# **ADDENDUM NO. 3**

## **BLACKSTONE BIKEWAY 3A-1 CONTRACT 1**

**BID #23-040**

**ISSUED: December 7, 2023**

**AREA 2 EXISTING CONDITIONS PLAN**

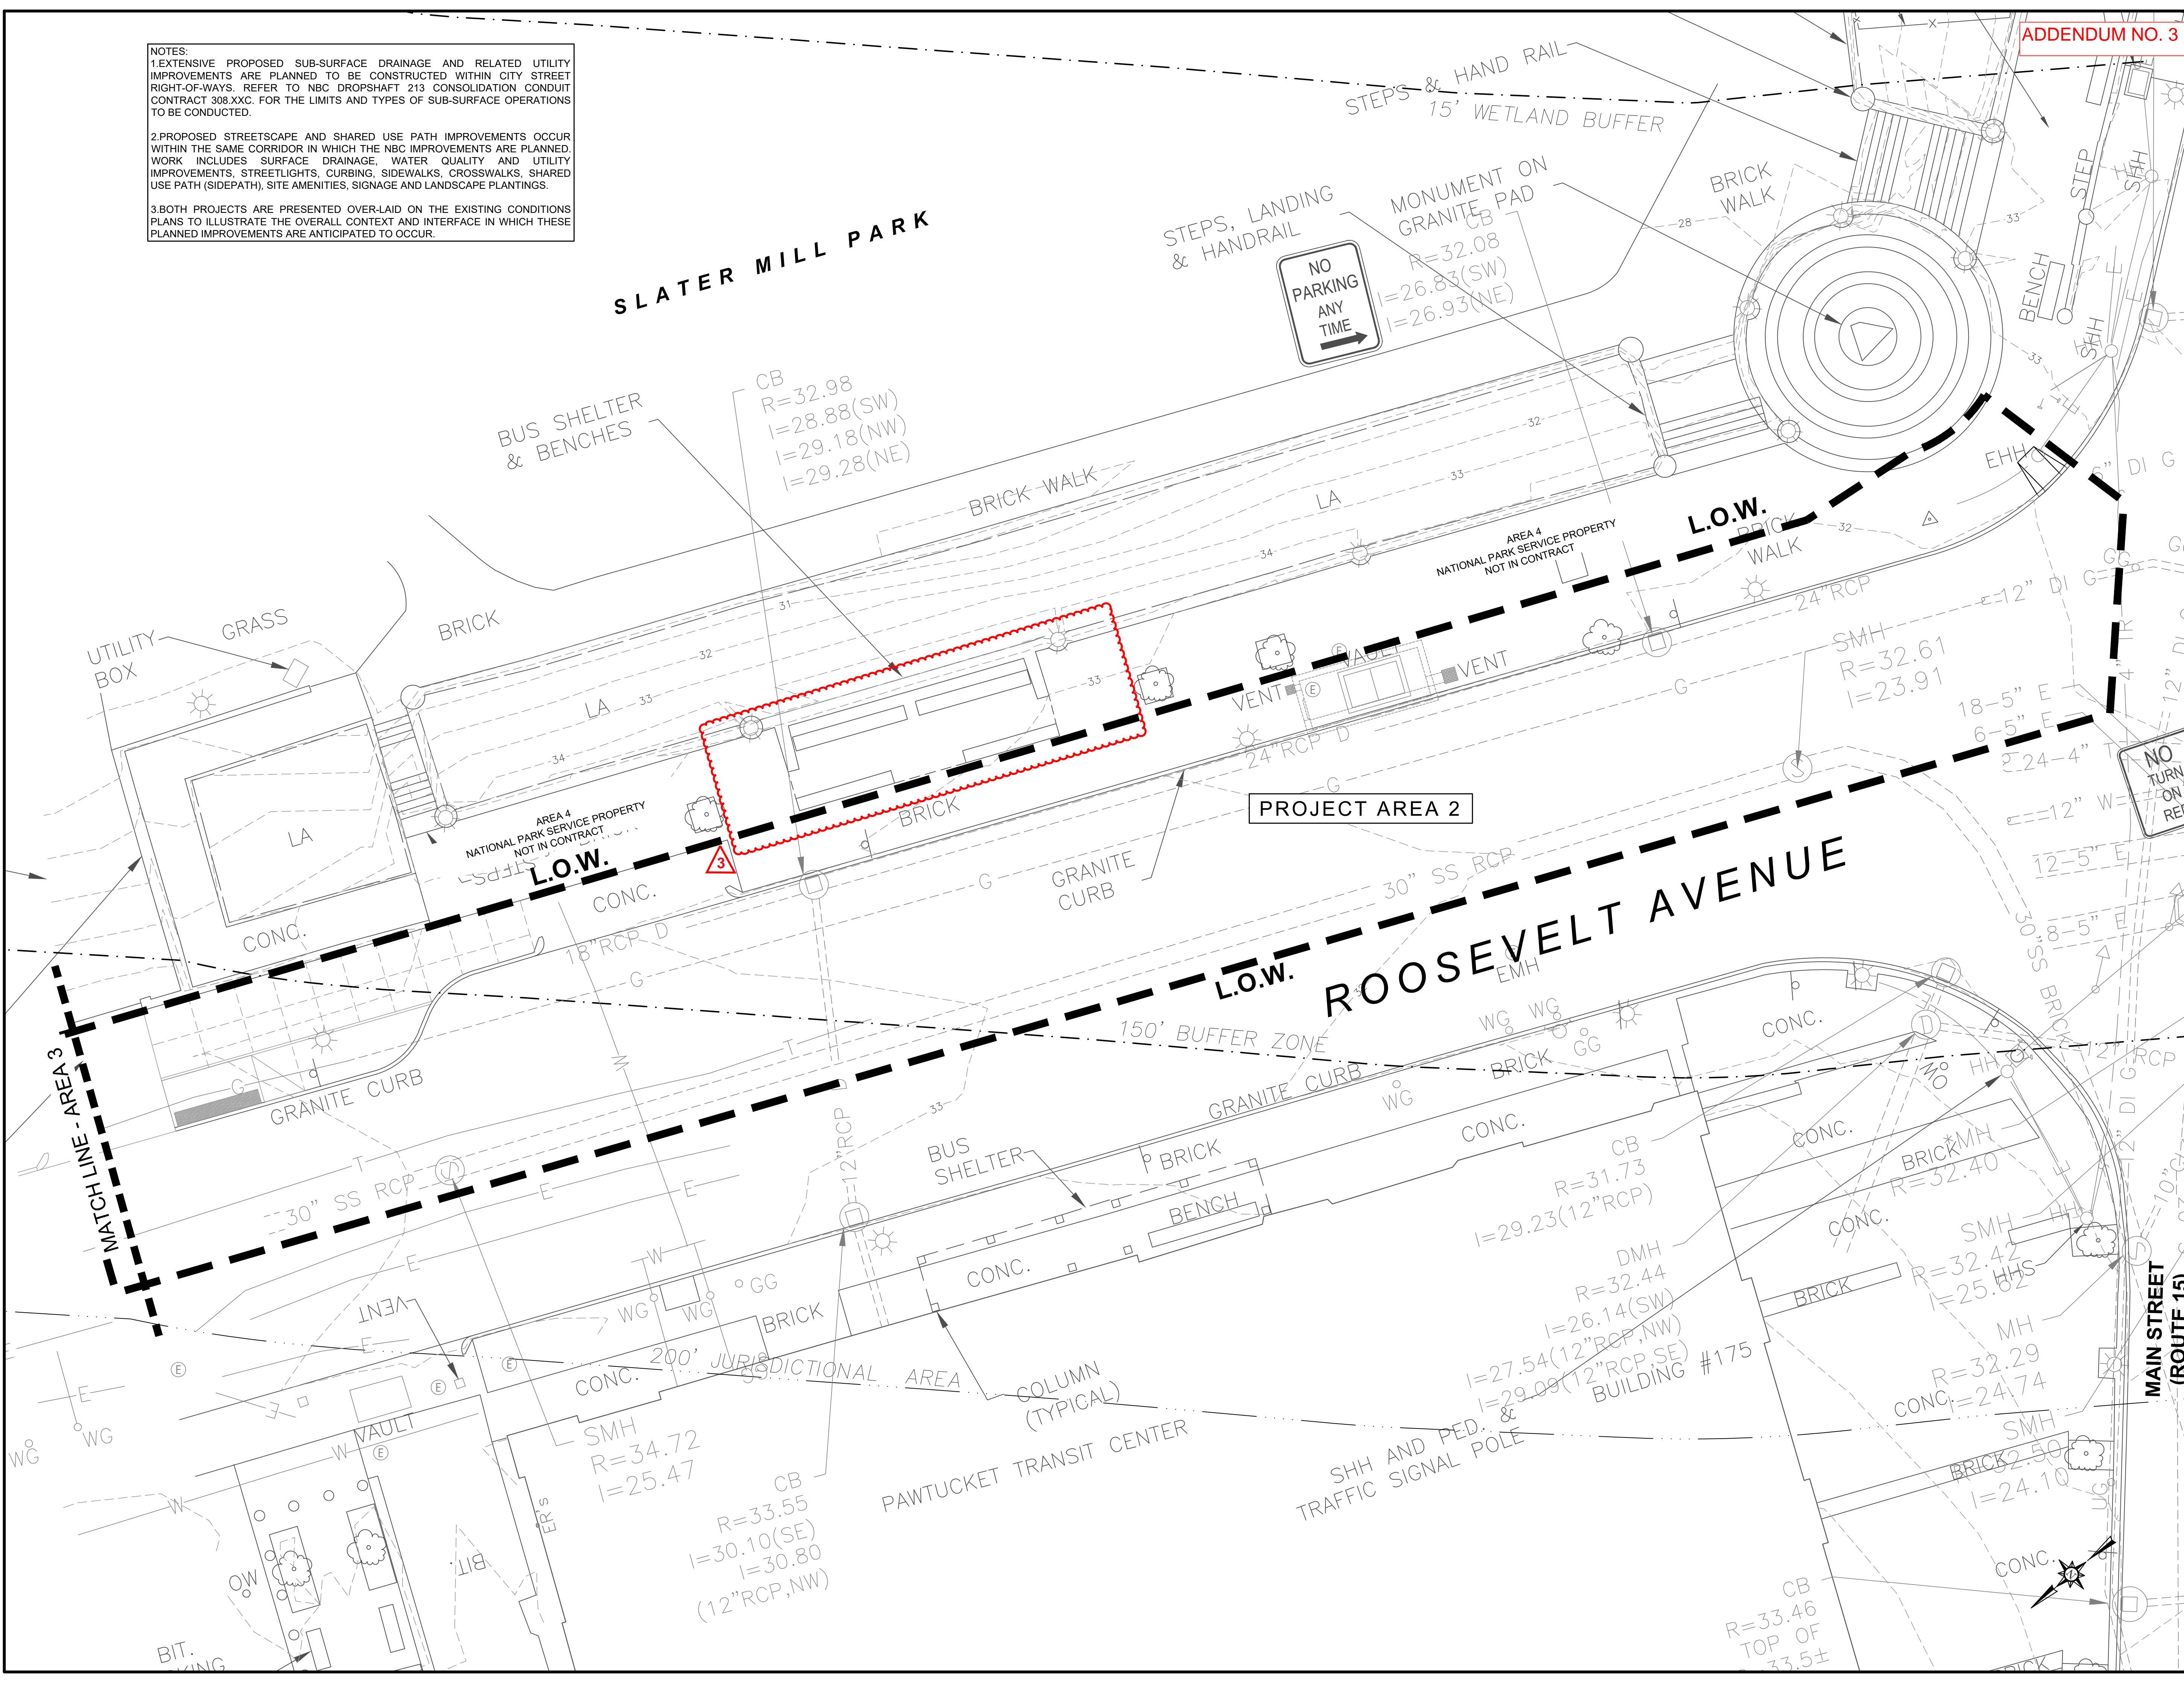
- v. Section 03900 Clean and Repair Wall has been eliminated in it's entirety from the project.
  - vi. Sheets 16 + 17 of the Drawings Issued for Bid have been revised to eliminate Removal of the Bus Shelter in it's entirety from the project.

- f. Plan Sheets 16 & 17 are deleted in their entirety and replaced with re-issued Plan Sheets 16 & 17 as part of this Addendum.
